SERVICE BULLETIN NO: NMD-79-6

TITLE: Oil - Revision of Oil Temperature Limits (Modification N640)

OIL - REVISION OF OIL TEMPERATURE LIMITS (MODIFICATION N 640)

Rework of Oil Temperature Indicator
Figure 1

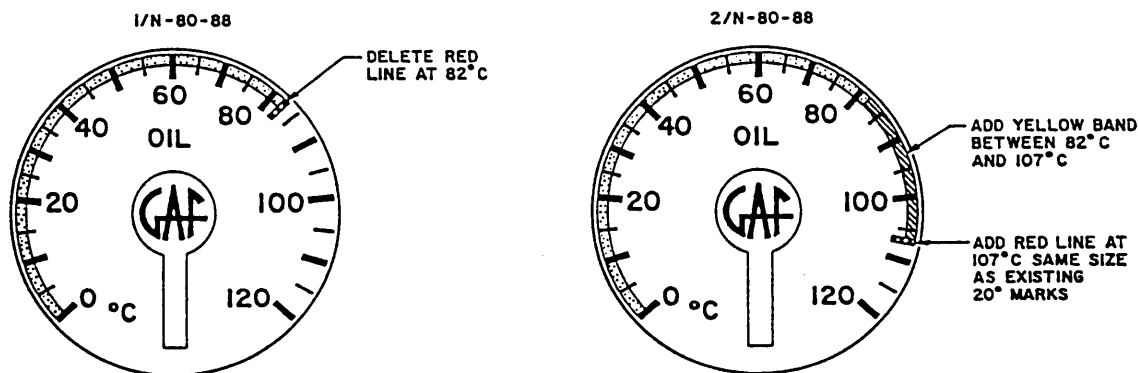
Engine oil temperature indicators P/N 1/N-80-88 are to be reworked to delete the existing red radial at 82 deg, add a yellow band between 82 deg and 107 deg and add a red radial at 107 deg.

- C. The oil temperature indicators removed at step (A) and spare oil temperature indicators P/N 1/N-80-88 are to be reworked as follows in an approved instrument workshop (Ref Fig 1):

- (1) Gain access to the dial (Ref Manufacturer's data).
 - (2) Obliterate the existing red radial mark at 82 deg C position by painting over with instrument matt black paint or suitable equivalent. If necessary, restore full coverage of existing green band to 82 deg C using green fluorescent paint to Federal Standard 595 Colour No. 38901.

- (3) Paint in a yellow band from 82 deg C to 107 deg C using fluorescent yellow to Federal Standard 595 Colour No. 38907.

- (4) Paint new red radial mark at 107 deg C position using fluorescent red to Federal Standard 595 Colour No. 38903.

- (5) Re-assemble the indicator (Ref Manufacturer's data).
- (6) Test the indicator as per Manufacturer's test data.
- (7) After satisfactory test has been completed, re-identify the indicator on the outside of the indicator case with part number 2/N-80-88/NMD-79-6.
- (8) Prepare spare indicators for storage and return to stores.
